# CHANDIGARH HOUSING BOARD

STANDARD DESIGN OF GENERAL HOUSING. CAT-2, SECTOR. 51 - A. CHANDIGARH. (U.T.)  
GROUND & TERRACE FLOOR PLAN

STANDARD DESIGN OF GENERAL HOUSING. CAT-2, SECTOR 51 - A, CHANDIGARH. (U.T.)

FIRST, SECOND & THIRD FLOOR PLAN

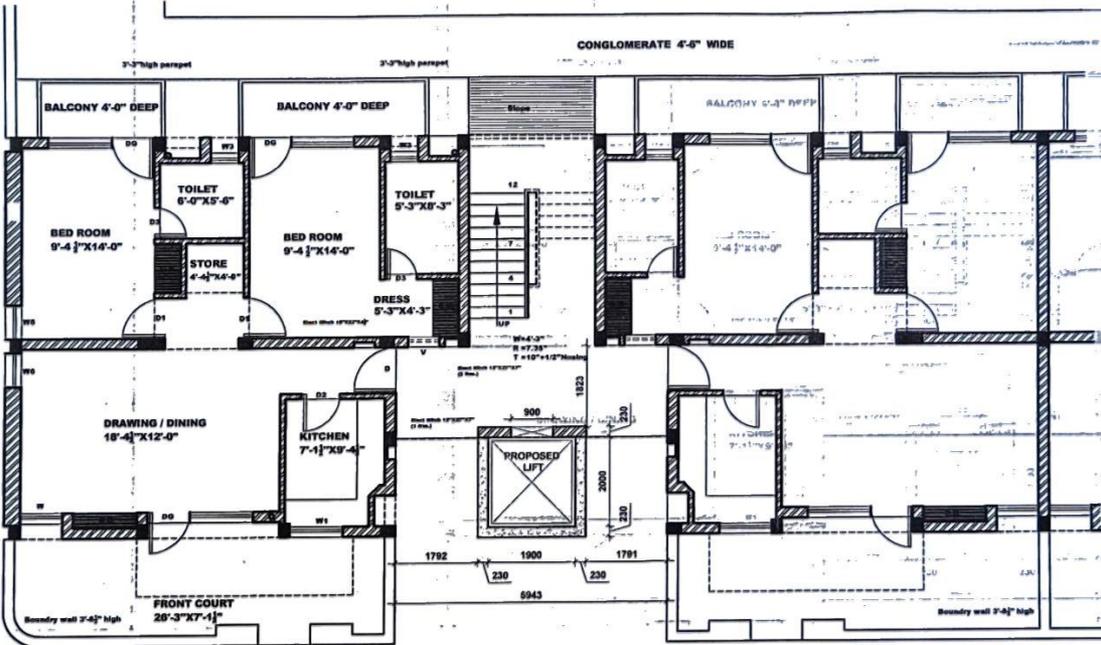
**NOTE:**  
This drawing supersedes drg. no. 67 Job no. 170 approved by PAC (L) on 29.07.2024. The car and the shaft size of the lift has been revised to 1100mm x 1300mm (car size) and 1900 mm x 2000mm (minimum) respectively with clear door opening of 900mm, as was decided in the meeting PAC (L) held on 25.05.2025, the decision of which was circulated vide memo no. 2273893 dated 26.06.2025. The conditions shall remain the same as approved earlier.

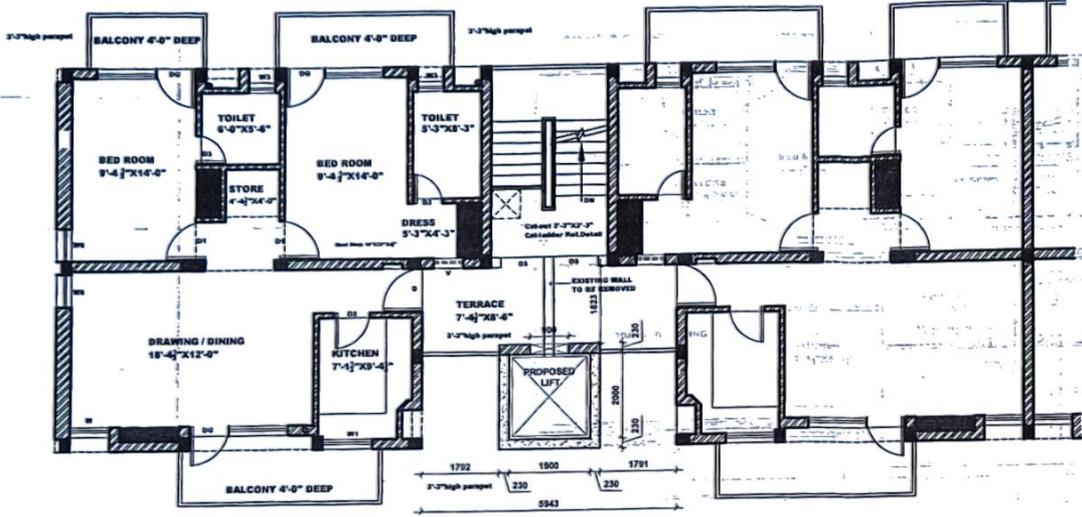
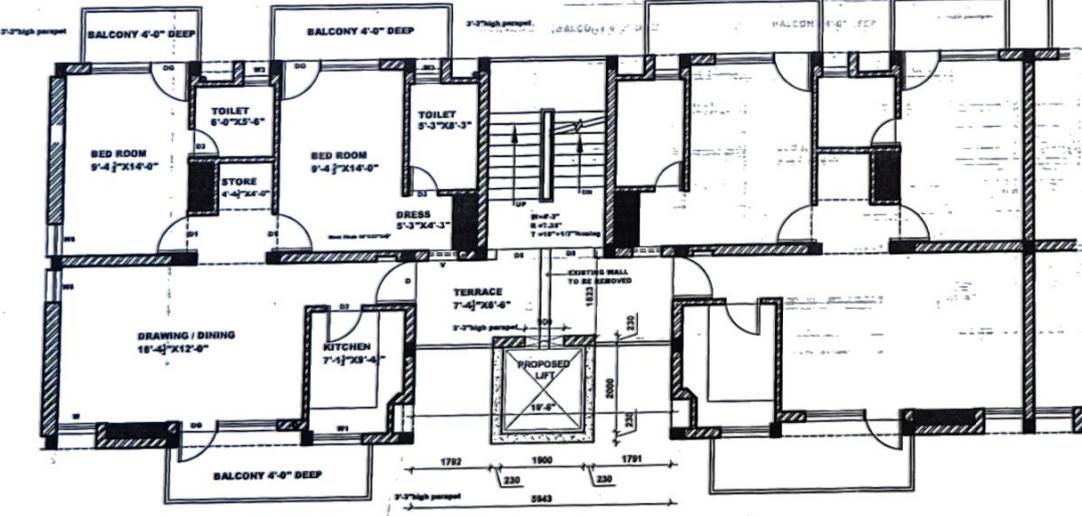
This drawing supersedes drg. no. 68 job no. 170 approved by PAC (L) on 29.07.2024. The car and the shaft size of the lift has been revised to 1100mm x 1300mm (car size) and 1900mm x 2000mm (minimum) respectively with clear door opening of 900mm, as was decided in the meeting PAC (L) held on 25.08.2025, the decision of which was circulated vide memo no. 2273893 dated 26.08.2025. The conditions shall remain the same as approved earlier.
